Memorandum

Project #: 12815.00

Re: South Coast Rail
Proposed Layover Facility in New Bedford
Responses to Comments

NEW BEDFORD MAIN LINE
WAMSUTTA LAYOVER AND TRACK PLAN
DETAILS 2

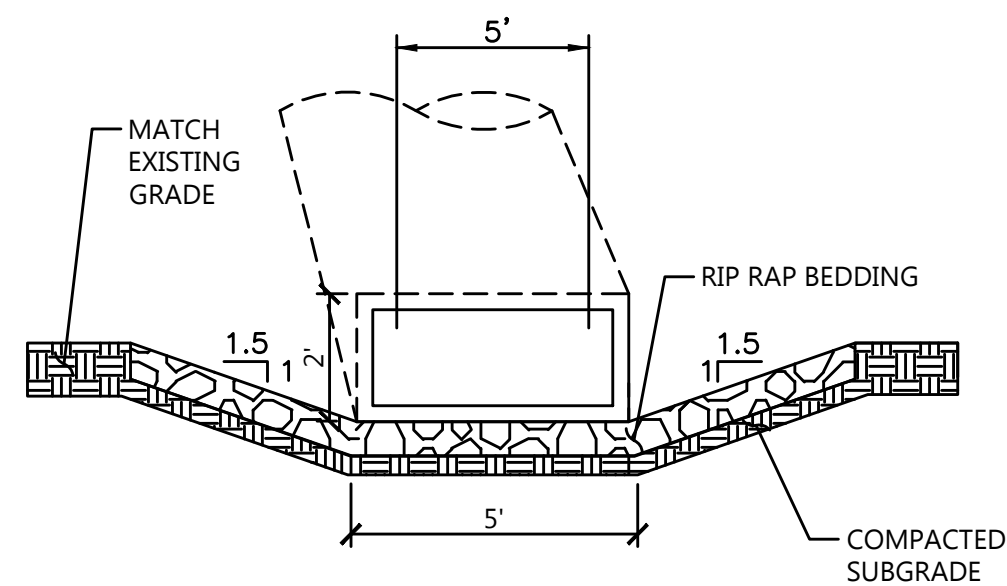
5. Comment: The proposed water quality inlet (WQI) tanks discharge into the ballast stone system. The outflow for the ballast stone system is a weir set at elevation 11.0 in DMH-6, which is above the inlet/outlet elevations of upstream structures including the WQI tanks. We recommend that the Applicant consider the addition of backflow valves on the outlets to the WQI tanks to prevent surcharging and resuspension within the tanks.

Response: A note has been added to the Water Quality Inlet detail indicating backflow prevention devices are to be provided on outlet pipes of the WQI tanks. The revised detail sheet is attached.

- Notes:
- PARTICLE SEPARATOR SHALL BE A PRECAST TANK WITH PRECAST BAFFLES AS SHOWN.
 - STRUCTURES SHALL BE DESIGNED FOR HS-20 LOADING.
 - PROVIDE OPENINGS FOR PIPES WITH 2" MAX. CLEARANCE TO OUTSIDE OF PIPE. MORTAR ALL PIPE CONNECTIONS.
 - JOINT SEALANT BETWEEN ALL SECTIONS SHALL BE PREFORMED BUTYL RUBBER
 - DRAIN MANHOLE FRAME AND COVER SHALL BE SET IN FULL MORTAR BED. ADJUST TO GRADE WITH CLAY BRICK AND MORTAR (2 BRICK COURSES TYPICALLY, 5 BRICK COURSES MAXIMUM)
 - BARREL BLOCK AND MORTAR SHALL BE USED TO BRING MANHOLE FRAME AND COVER TO FINISHED GRADE WHEN DEPTH TO TOP OF STRUCTURE EXCEEDS 24 INCHES.
 - PROVIDE BACKFLOW PREVENTION DEVICE ON OUTLET PIPES OF ALL WATER QUALITY INLET TANKS.

Figure 4

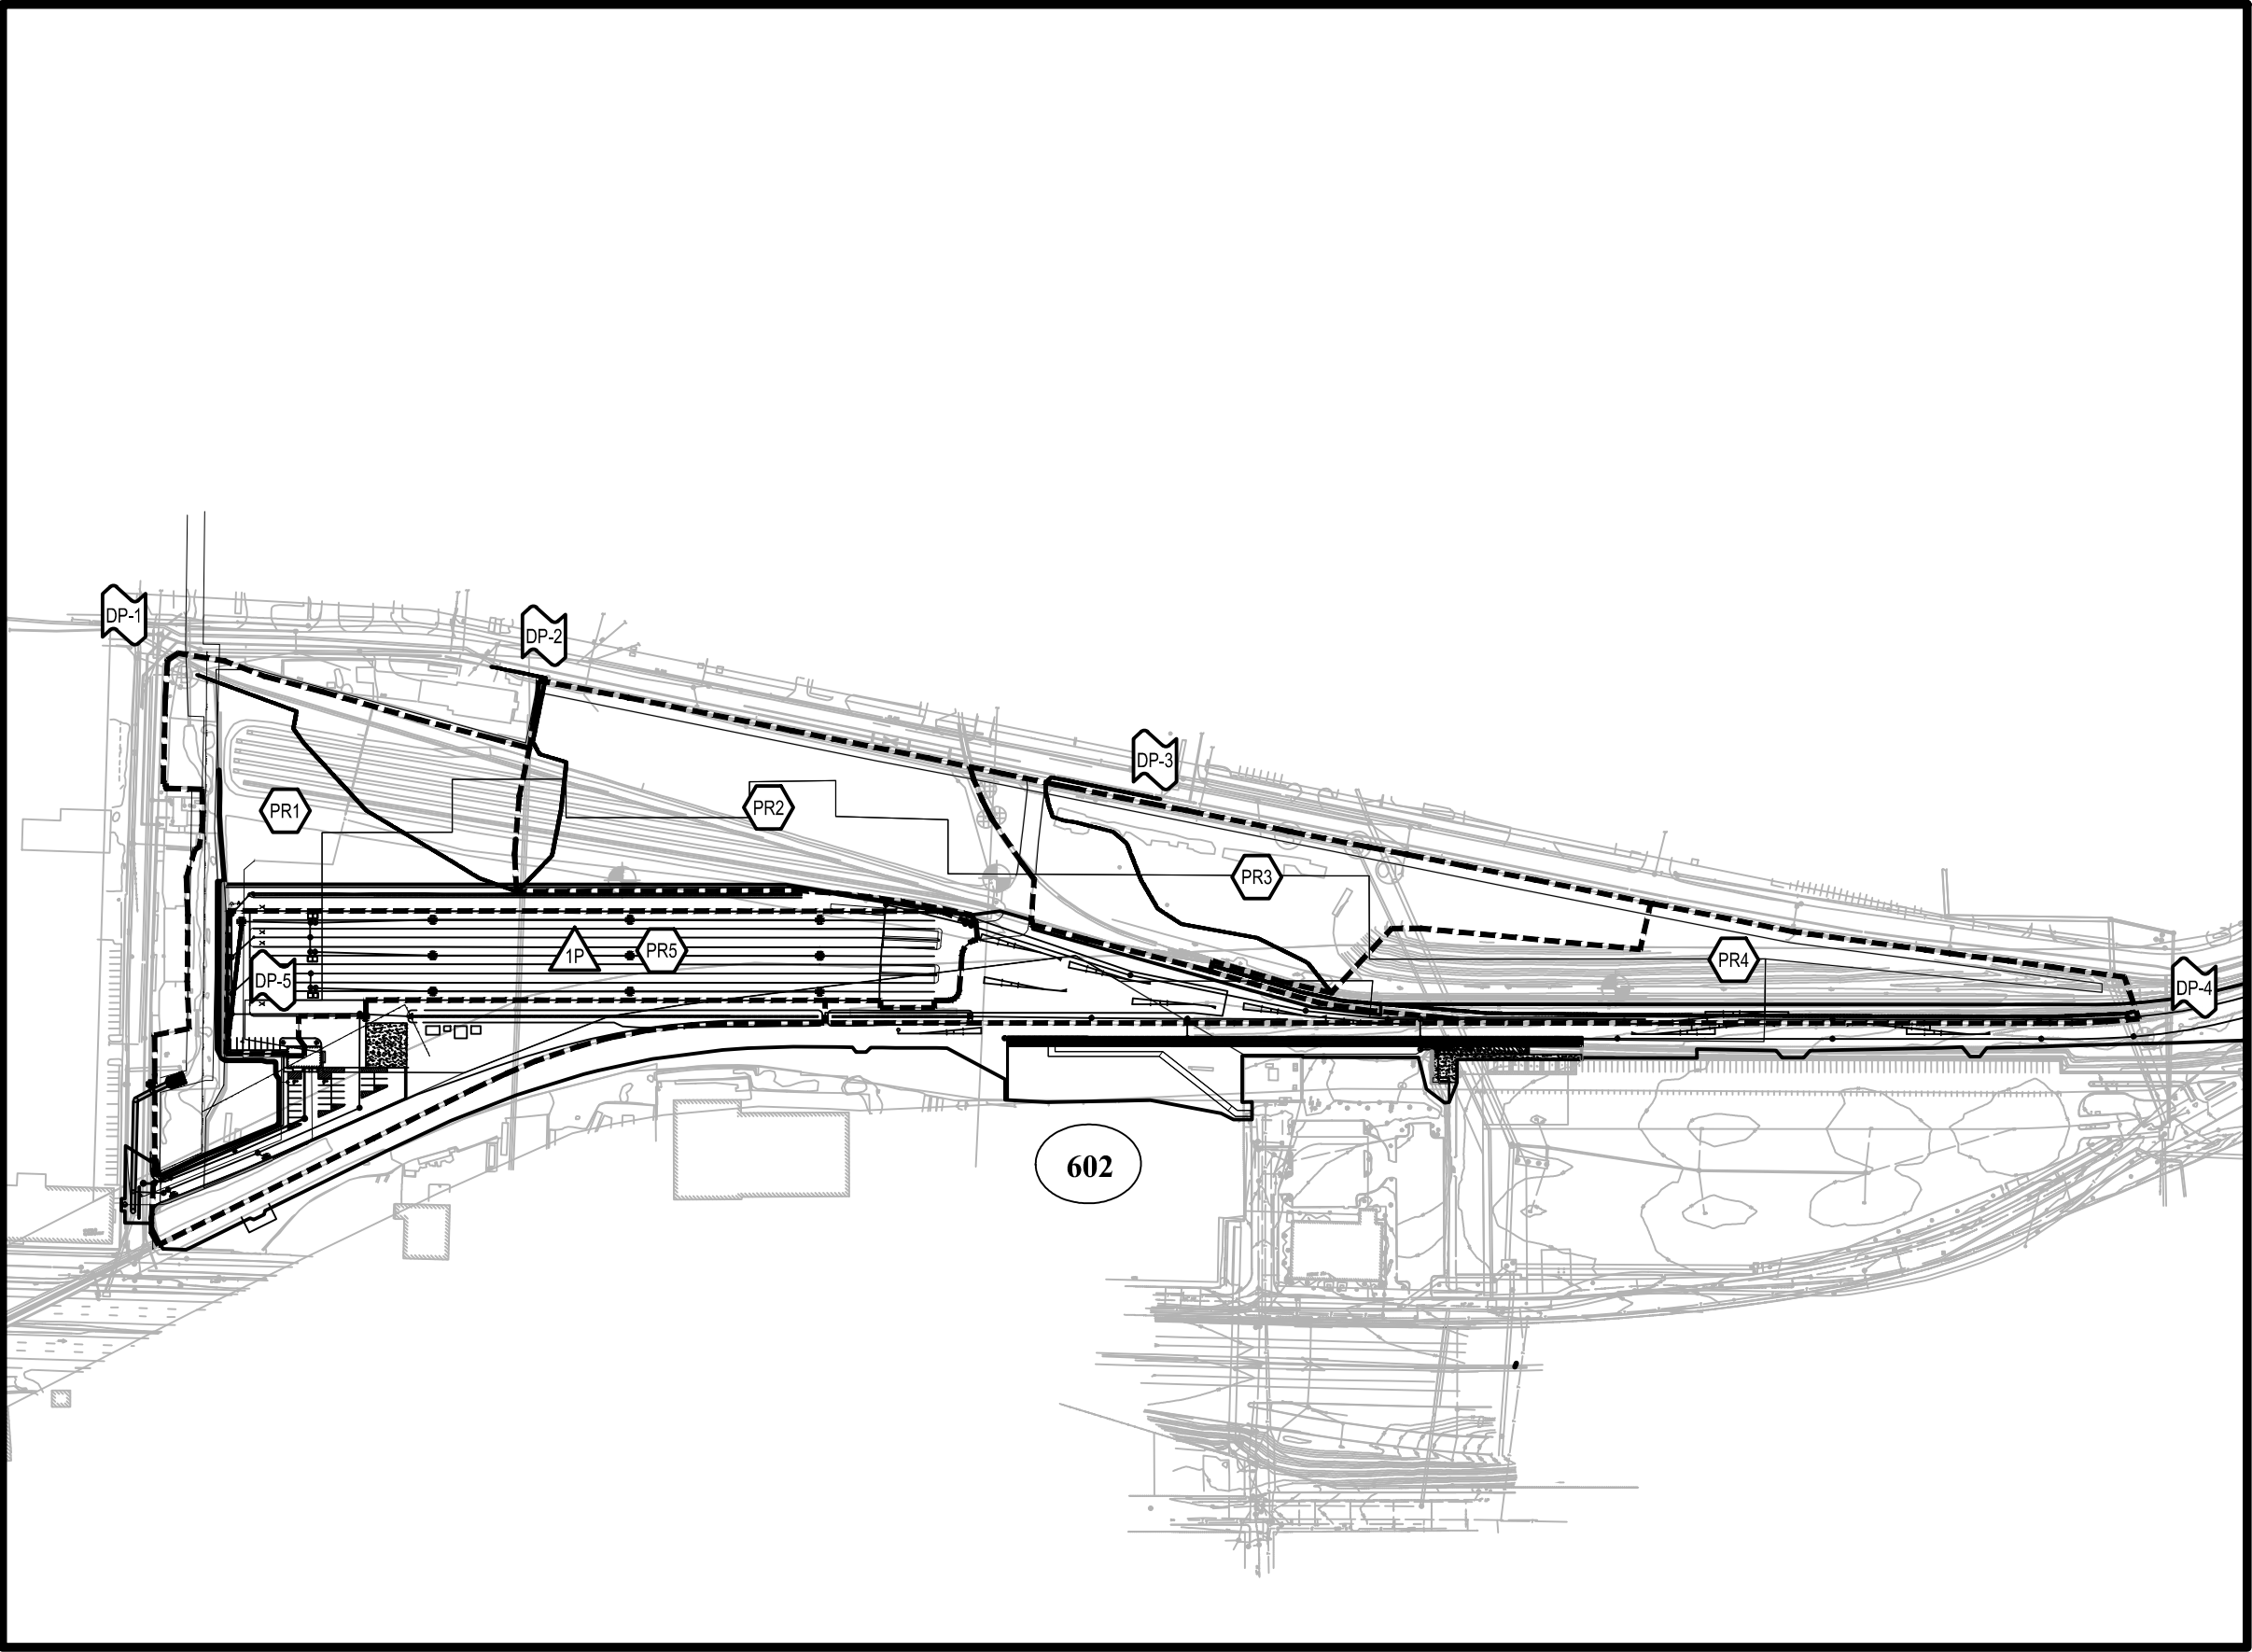
4. Comment: The Proposed Drainage Plan should be revised to reflect the current headwall and riprap apron locations for the 5-foot by 2-foot box culvert.

Response: The Proposed Drainage Plan has been revised as requested and attached hereto.
